## Product Advisory (PA)

**Subject:** Changes to the Power-up / Power-down Sequencing and Recovery from Brown-out Condition

This notice is to inform you that the High-Performance Serial MRAM Memory datasheet has been updated as follows:

**Figure 1: Power-Up Behavior**

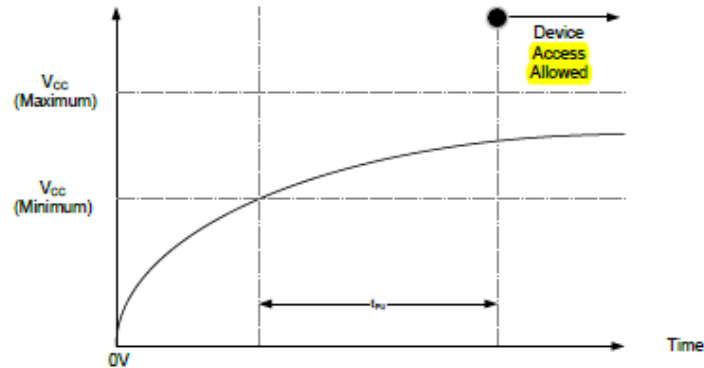
When powering up, the following procedure is required to initialize the device correctly:

- Ramp up  $V_{CC}$  ( $t_{RVR}$ )
- CS# must follow  $V_{CC}$  during power-up (a 10K $\Omega$  pull-up Resistor to  $V_{CC}$  is recommended)
- It is recommended that no instructions are sent to the device when  $V_{CC}$  is below  $V_{CC}$  (minimum)
- During initial Power-up, recovering from power loss or brownout, a delay of  $t_{PU}$  is required before normal operation commences
- Upon Power-up, the device is in Standby mode

**Figure 7: Power-Down and Brown-out Behavior**

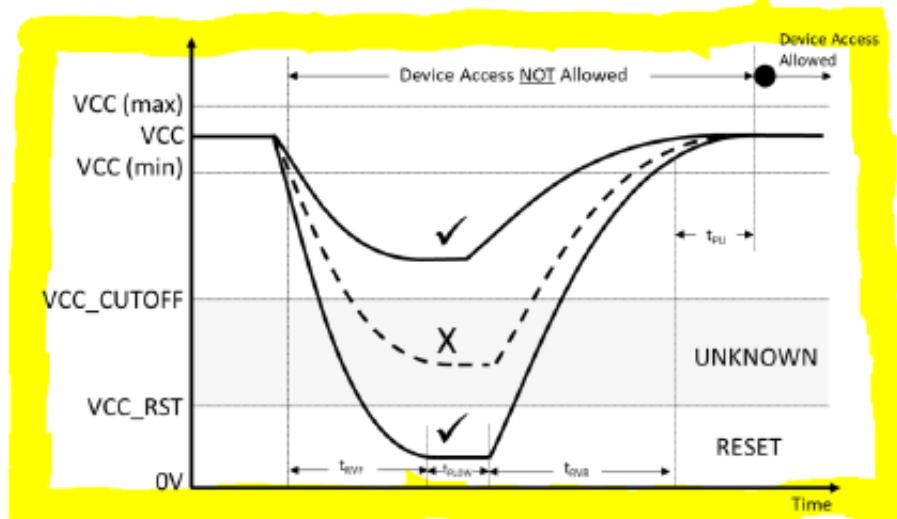
When powering down or in case of brown-out, the following procedure is required to turn off the device correctly:

- Ramp down  $V_{CC}$  below  $V_{CC\_RST}$  level
- CS# must follow  $V_{CC}$  during power-down (a 10K $\Omega$  pull-up Resistor to  $V_{CC}$  is recommended)
- The device must not be selected and that no instructions are sent to the device when  $V_{CC}$  is below  $V_{CC}$  (minimum)
- The Power-up timing and device initialization needs to be observed after  $V_{CC}$  ramps up above  $V_{CC}$  (minimum)
- To stabilize the  $V_{CC}$  level, suitable decoupling capacitors close to package  $V_{CC}$  pin is recommended
- Chip functionality not guaranteed if  $V_{CC}$  ramps down between  $V_{CC\_CUTOFF}$  and  $V_{CC\_RST}$  and then ramps up to  $V_{CC}$
